| <b>Model</b>                   | VT2300/2500, Ges5330, Rex1260, NSA CP330 | <b>Volt/Hz</b> | <b>Date of Modification</b> | <b>Serial Number</b> |
| <b>Modified Article</b>        | Parts Catalog                            |                |                             |                      |
| <b>Reason for Modification</b> | Parts catalog correction                 |                |                             |                      |

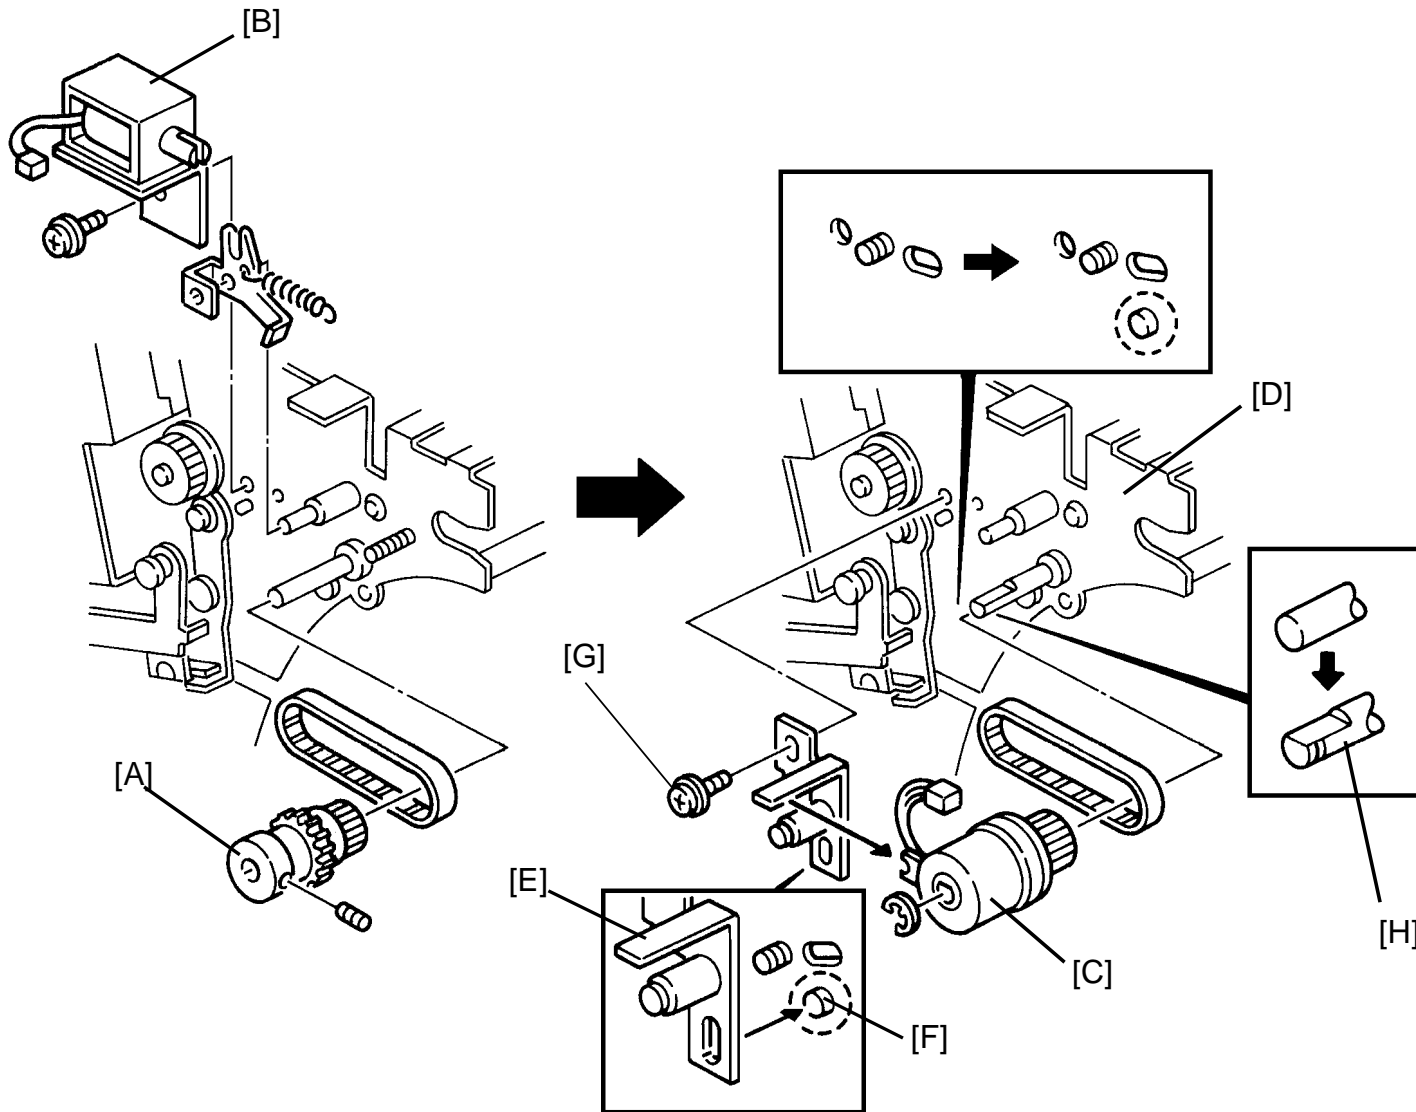
It has been found that a horizontal thin white line appears 64 mm from the leading edge of prints. The line may be visible when the image is made using the photo mode. This line is caused by a shock wave when the master is clamped by the drum master clamber.

1. To erase this white line, the software has been changed to delay the timing of the master clamping. With the old software, the reverse roller solenoid [A] and the master clamber solenoid were turned off at the same time. (Due to the slow response of the old spring clutch, the reverse roller stops feeding the master after the master was clamped.) The new software enables that the master is clamped when the master is fed 2 mm further after the reverse roller stops feeding the master. This allows to make a small buckle of the master, which absorbs the shock wave, between the platen roller and the reverse roller before the leading edge of the master is clamped.

The new ROM can be used also for existing machines. The only side effect is that the image on prints is forwarded about 1 or 2 mm due to the slow response of the old mechanism. (This value varies due to ratchets of the clutch gear.) If the old ROM is used for a modified machine (this is the same situation as the new clutch mechanism installed on the old machine), the image is shifted approximately 0.6 mm backwards.

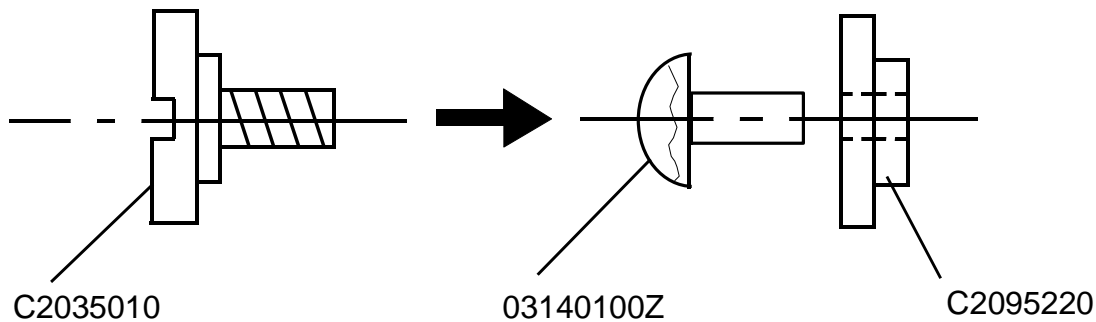
To facilitate servicing, the stepped screw supporting the paper feed pressure lever has been changed with a combination of a spacer and a philips screw - M4 x 10.

**Page 31 PRESS ROLLER SECTION**

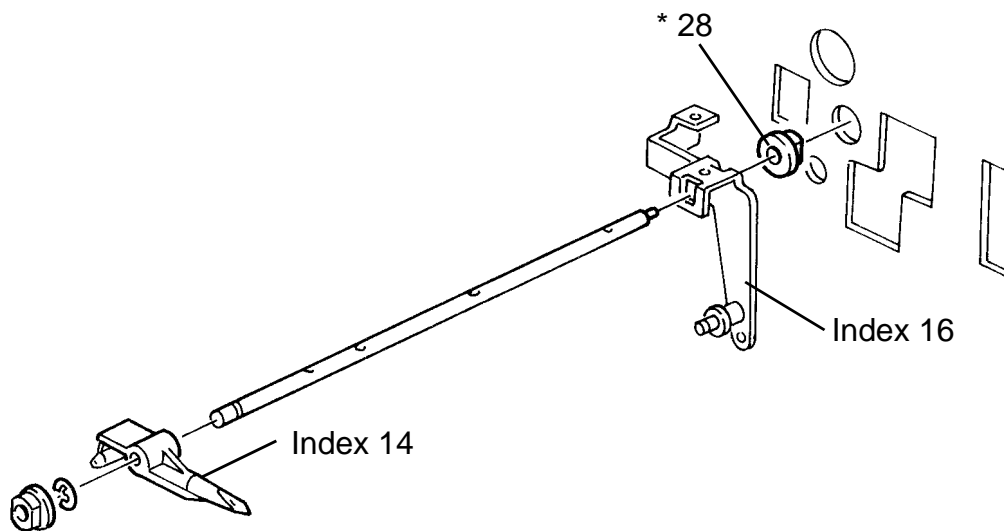
Add the following part:

| New Index | Part Number | Description       | Q'ty |
|-----------|-------------|-------------------|------|
| 28        | C2032083    | Exit Pawl Bushing | 1    |

**Page 56 PLOTTER / MASTER FEED SECTION II**

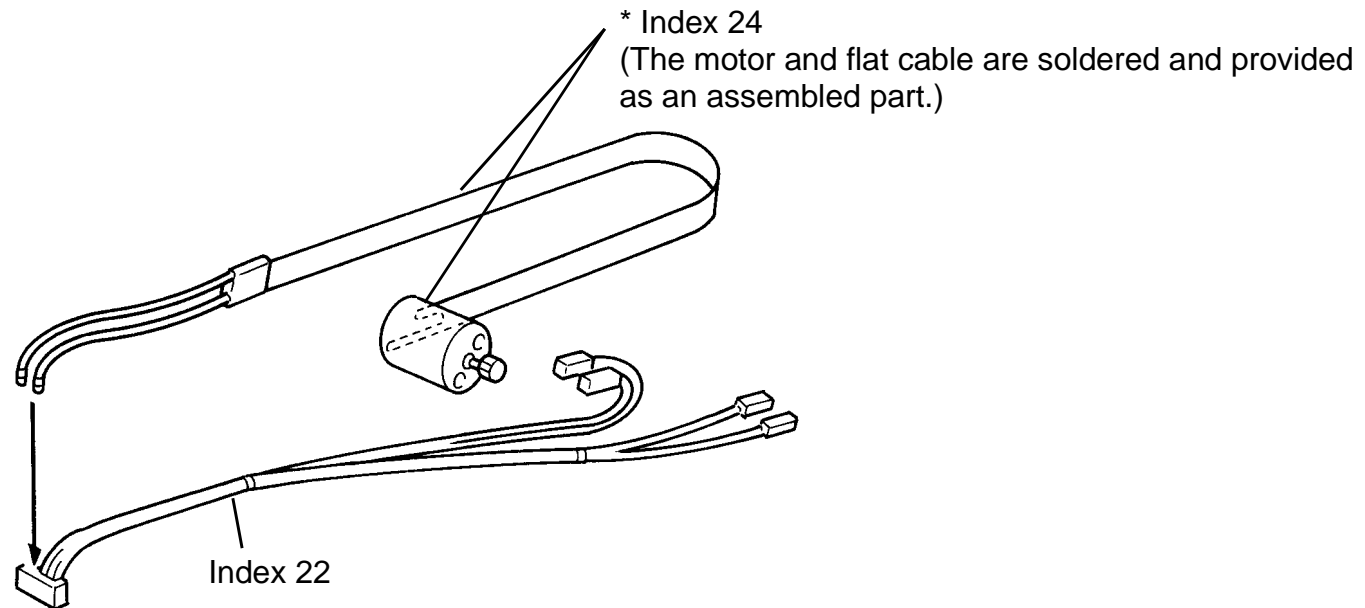
Correct the illustration for the cutter motor (C2008415) as follows:

**Page 59 PLOTTER / MASTER FEED SECTION III**

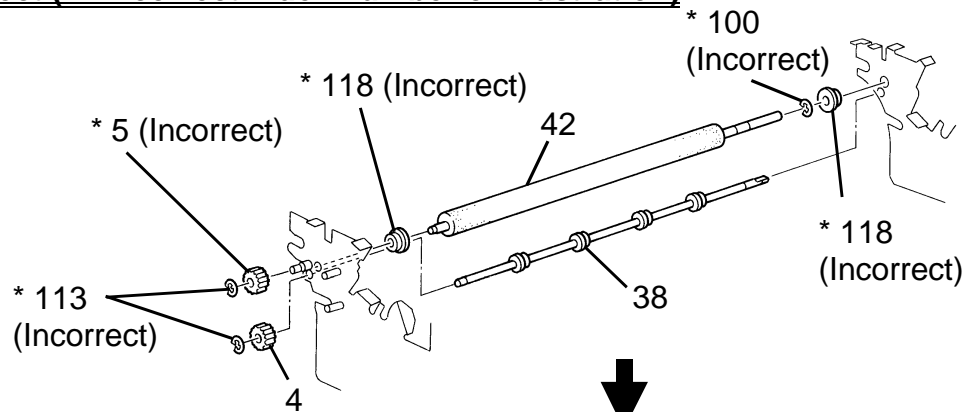
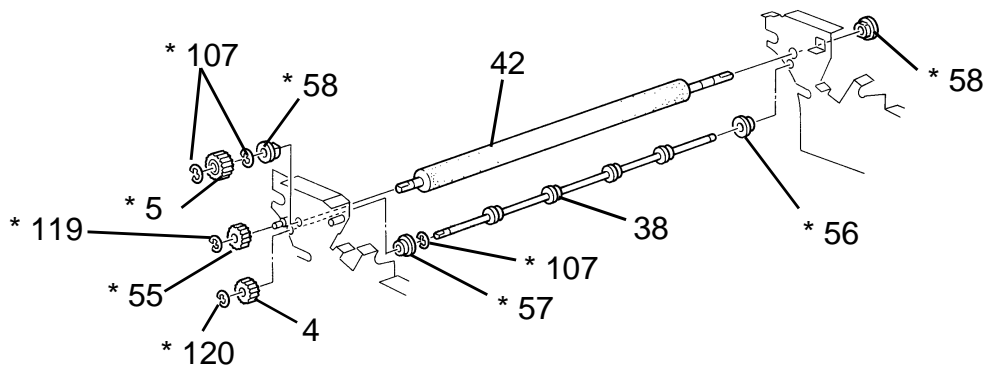
Add the following parts and correct the illustration as shown below:

**Incorrect (\* : Incorrect index number or illustration)**

**Correct (\* : New index number or corrected illustration)**

Drawing No. 1

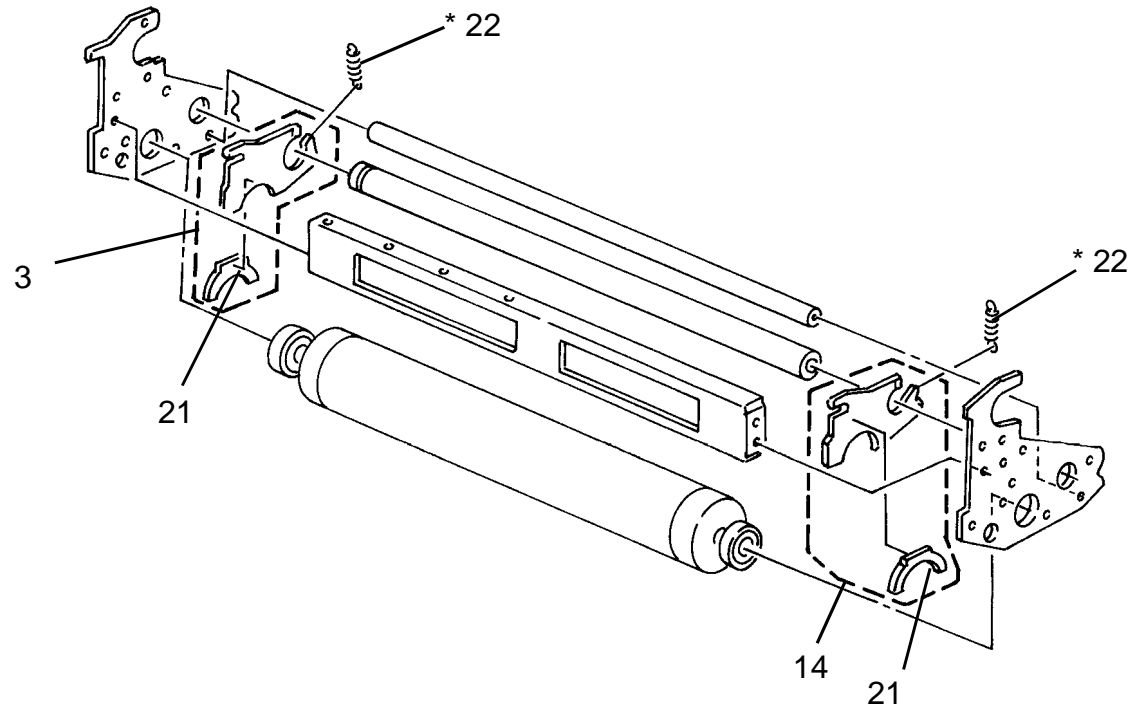
| <b>Model</b>                   |                      | VT2300 / 2500, Ges 5330, Rex1260, NSA CP330    |                                |             |                          |                             | <b>Volt/Hz</b>                                  | <b>Date of Modification</b> | <b>Serial Number</b> |             |
|--------------------------------|----------------------|--|--------------------------------|-------------|--------------------------|-----------------------------|---|-----------------------------|----------------------|-------------|
| <b>Reason for Modification</b> |                      | Due to parts standardization with other models |                                |             |                          |                             |   |                             |                      |             |
